Decoupling TSN YANG modules from .1Q bridge

P802.1Qcw/D1.2 comment resolution

Comments #13, #14, #15, #16 against P802.1Qcw/D1.2:

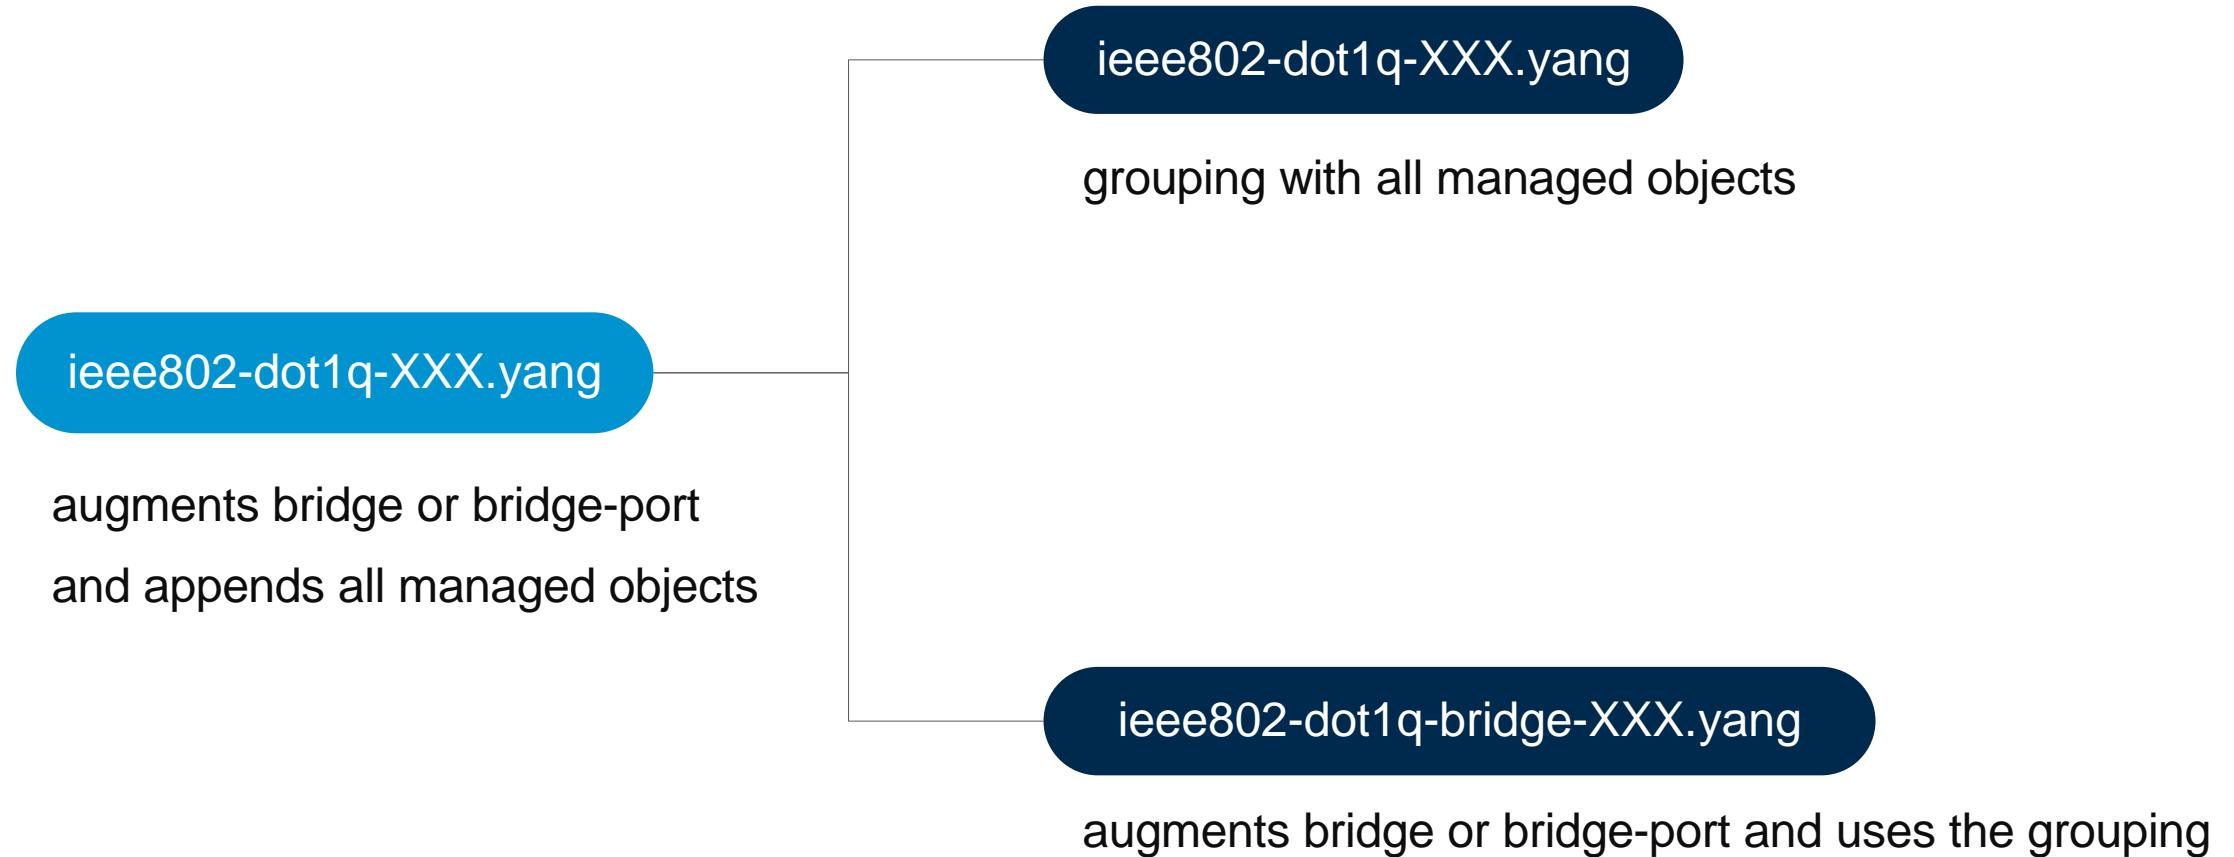
→ “*Tie QoS variables to Interfaces, not bridge-port.*”

Proposal from YANGsters (Scott Mansfield)

→ Copy Qcx!

What about other “TSN” modules?

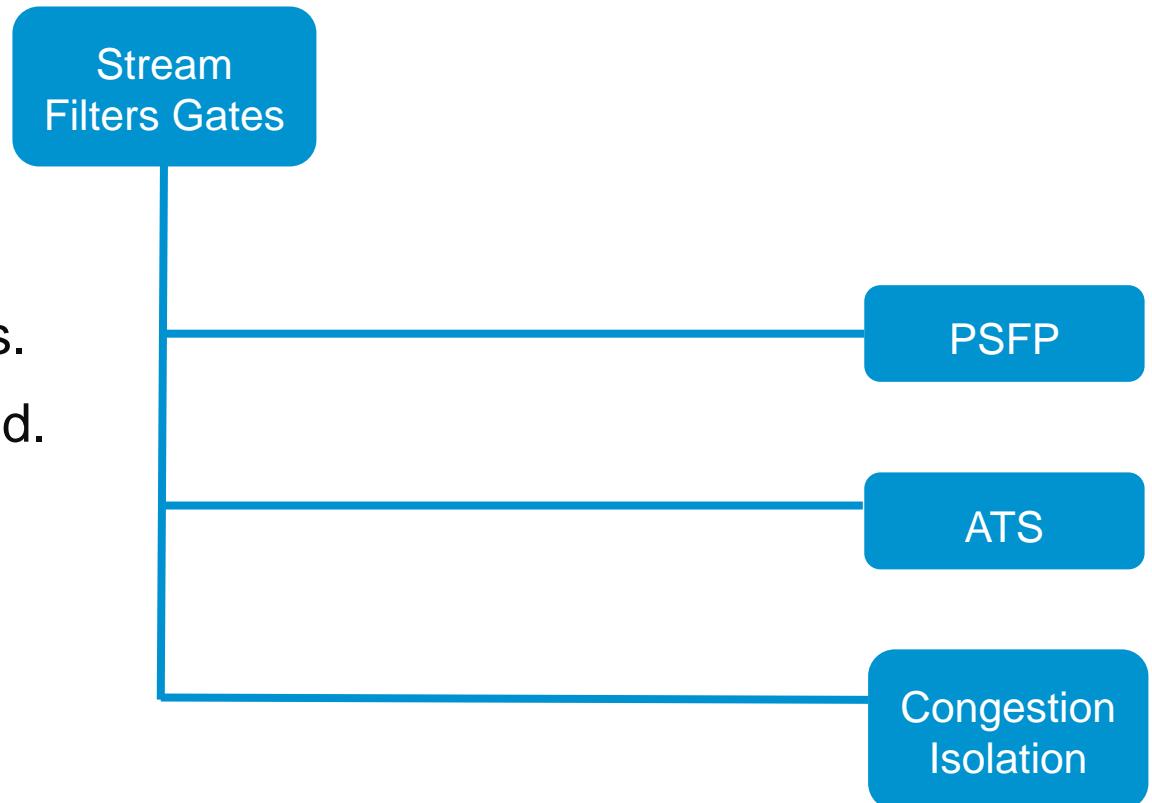
Are there other YANG modules that would be impacted / benefited by this change?

- Changing the structure of Stream Filter gates model breaks ATS and Congestion Isolation models.
- ATS and Congestion Isolation should be re-structure in the same way as Stream Filter Gates.
- The effort needed for this change must be studied.
